SAN ANTONIO WATER SYSTEM
W6: Western Watershed Sewer Relief Line – Project 2
SAWS Job No. 13-2501
Solicitation No. B-13-005-DD

ADDENDUM NO. 3
June 19, 2013

PLAN AND PROFILE
 STA 77+00 TO STA 88+00
 NEW LAREDO CROSSING
 SIPHON No 3

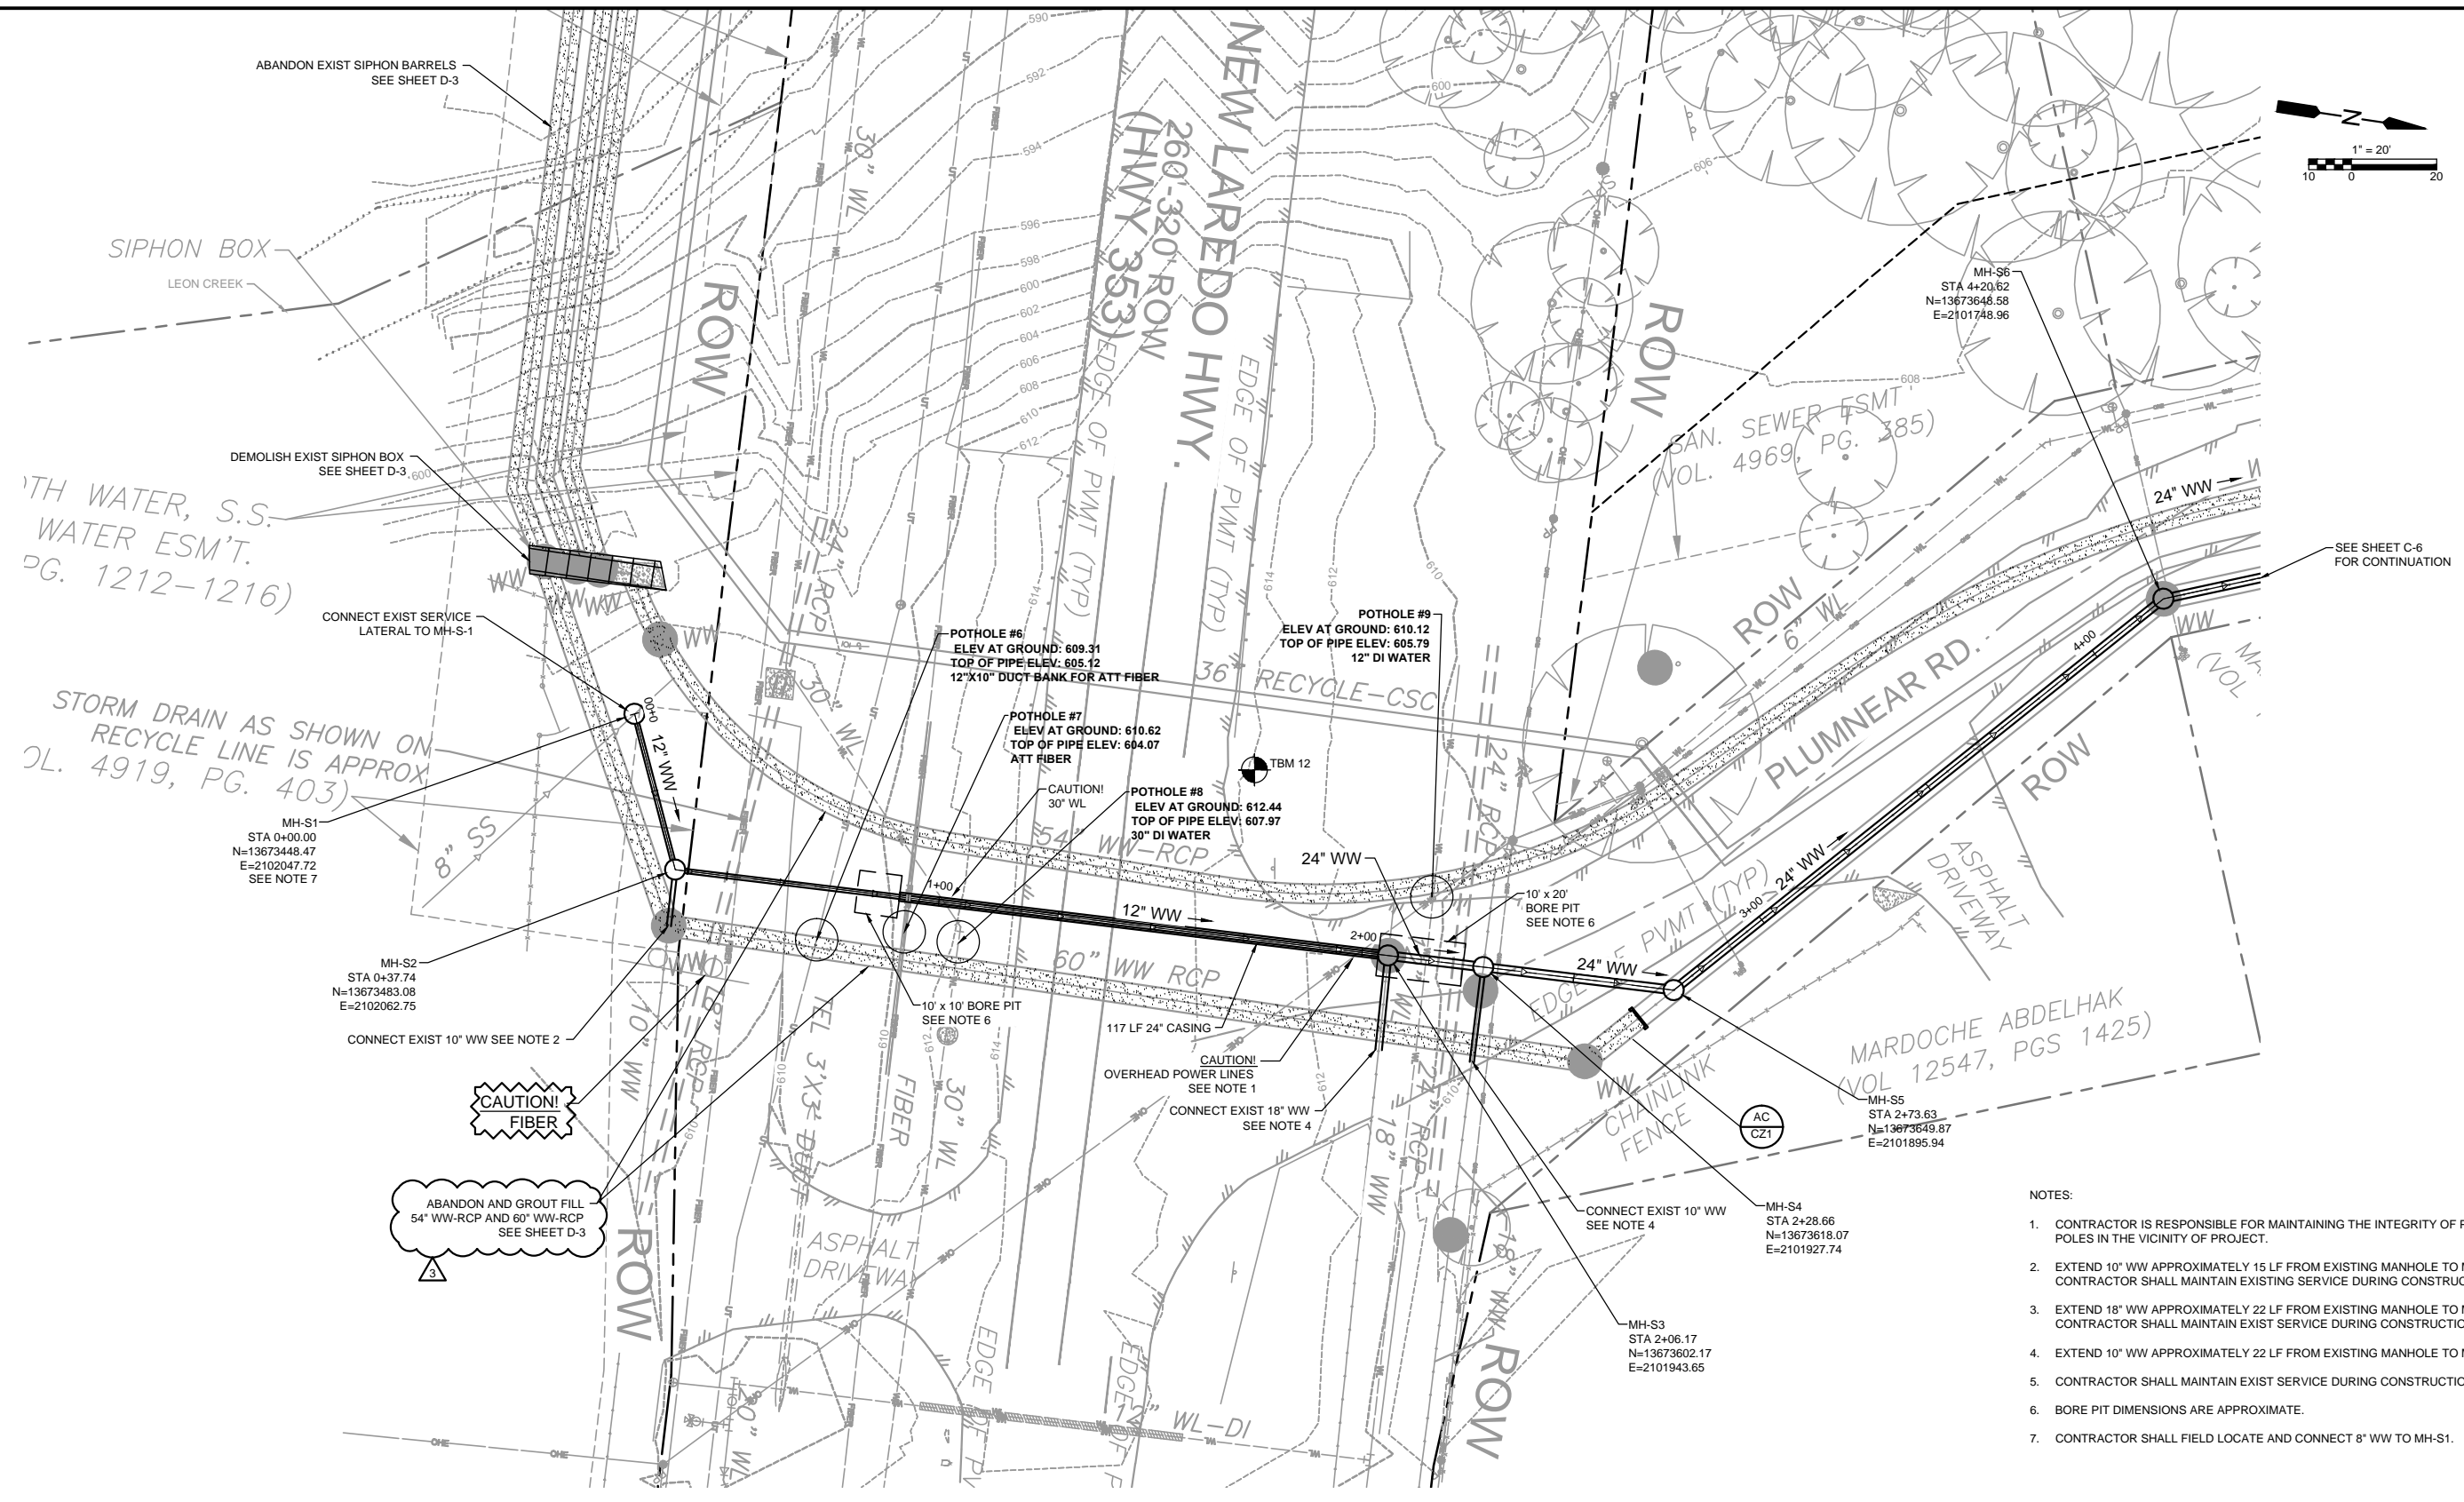
Q: There is a note on sheet C-3 above the profile view “24” SN 72 FRP see Sheet C-12 for continuation” Is there supposed to be a sheet C-12? The set goes to Sheet C-8.

A: *Sheet callout C-12 has been changed to C-7, revised sheet attached.*

PARTIAL PLAN
 SERVICE LINE CONNECTION
 NEW LAREDO HWY. CROSSING

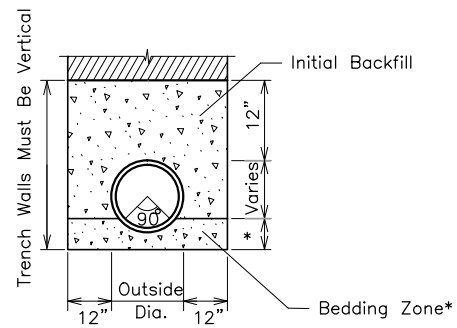
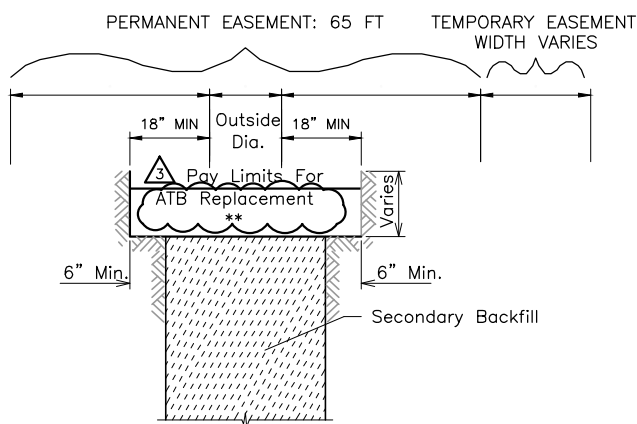
Q: There is a note on sheet C-7 on the lower left side “Abandon and grout fill 54” WW RCP and 60” WW RCP see sheet D-5” Is there supposed to be a sheet D-5? The set goes to sheet D-3.

A: *Sheet callout D-5 has been changed to D-3, revised sheet attached.*

SUGGESTED 30" WW FLOW MANAGEMENT DETAIL

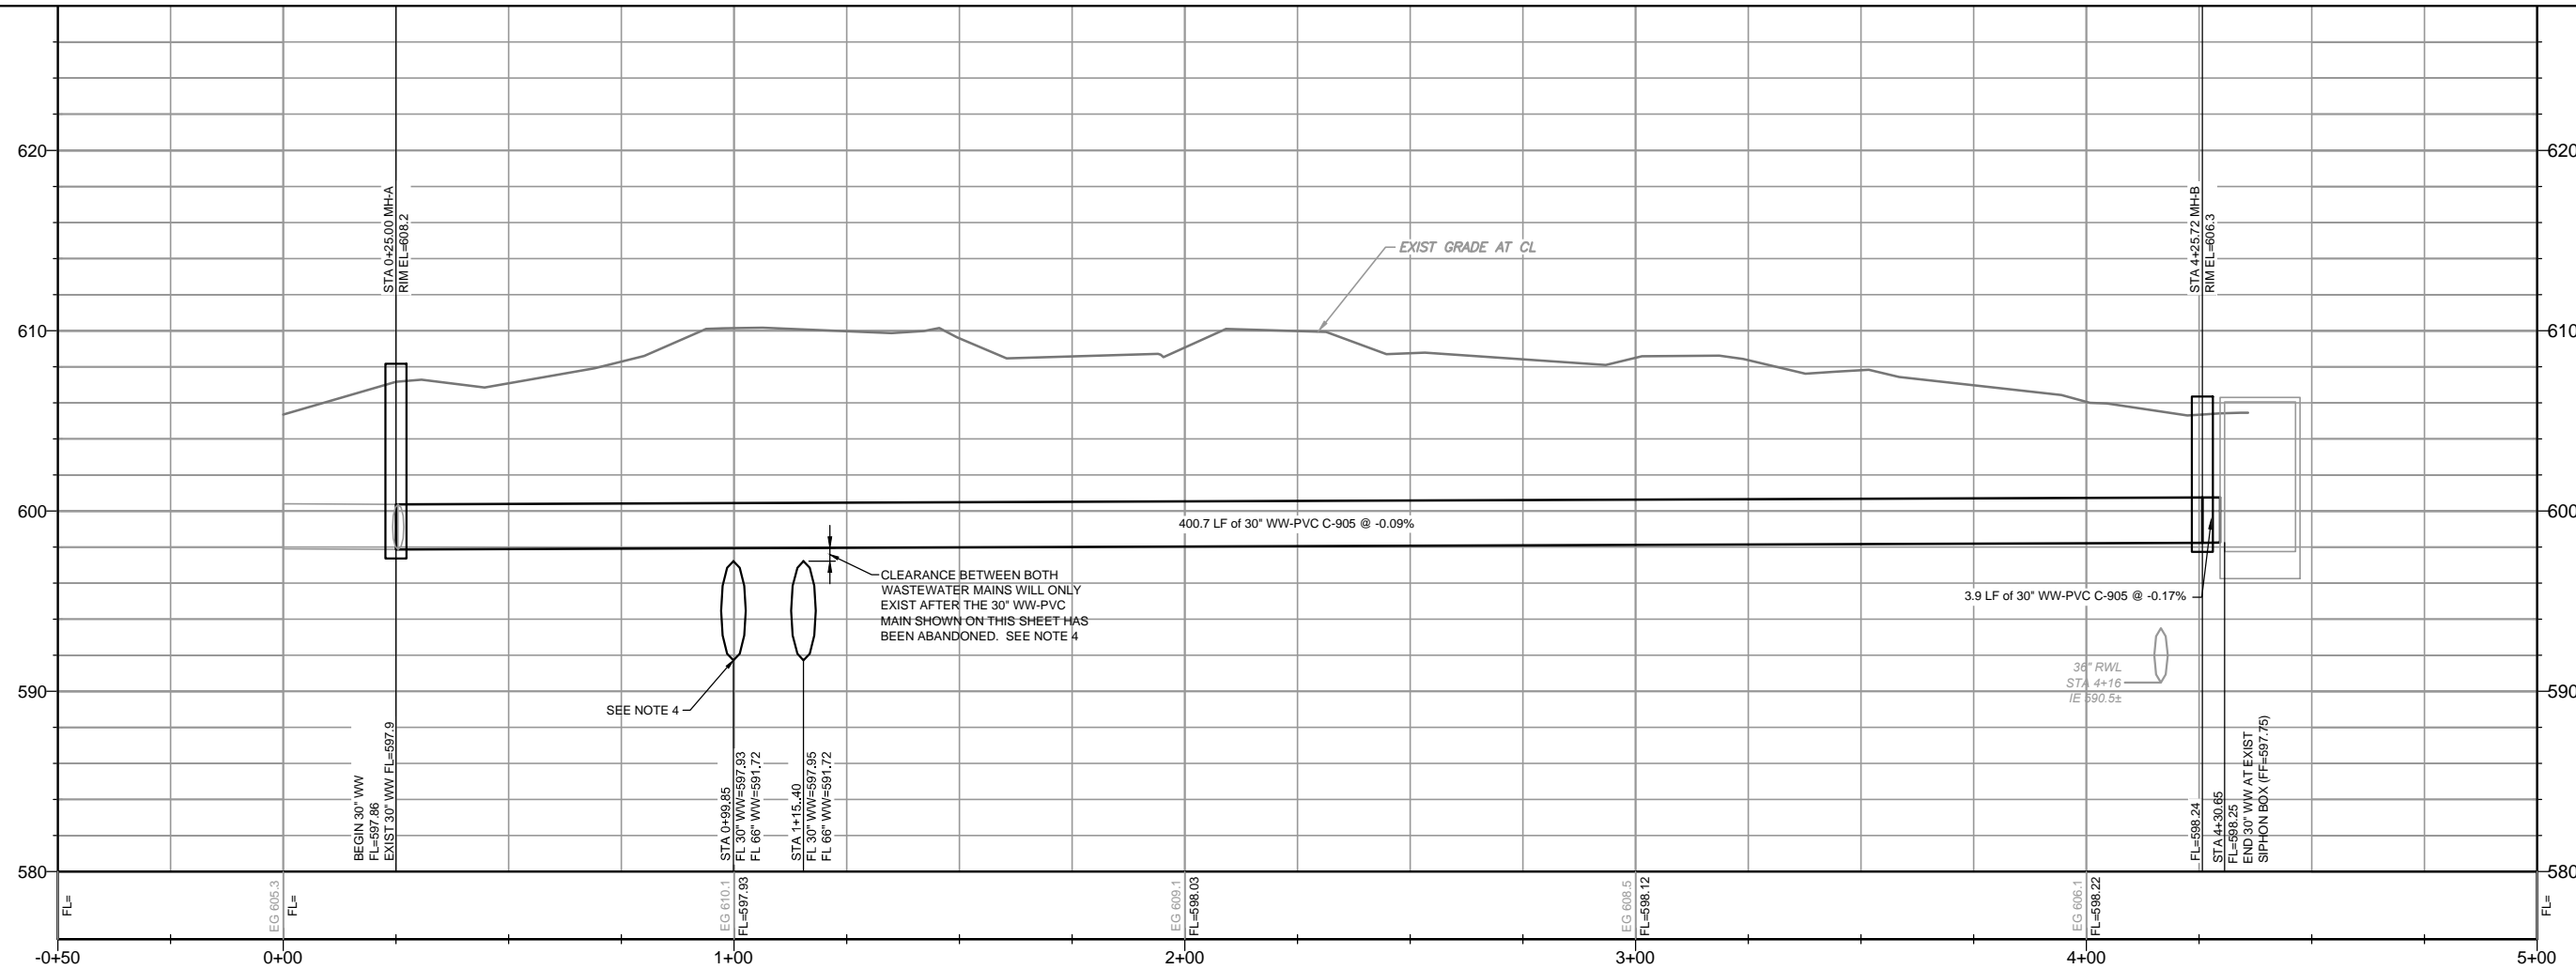
- Sheet CZ-7 Flow Management Detail was not included in the package. Include in sheet in Final Addenda.
- Quantities on Sheet G-4 to be verified and adjusted if necessary after all questions have been received and Final Addenda prepared.
- Question raised on where Item 107.1 Embankment was located or how it was calculated.
- Question raised on thickness of steel casing per SAWS standard material not listed in table.
- Addendum to be issued to change deadline for written question submission to 4 pm, Tuesday, June 18, 2013. Release date of Final Addenda will not change.

10. **Construction Plans - Sheet CZ-5:** Civil Details V will be deleted in its entirety and replaced. (SEE ATTACHED SHEET CZ-5, 11x17 sheet).
11. **Construction Plans - Sheet CZ-7:** Suggested 30" WW Flow Management Detail will be added in its entirety. (SEE ATTACHED SHEET CZ-7, 11x17 sheet).
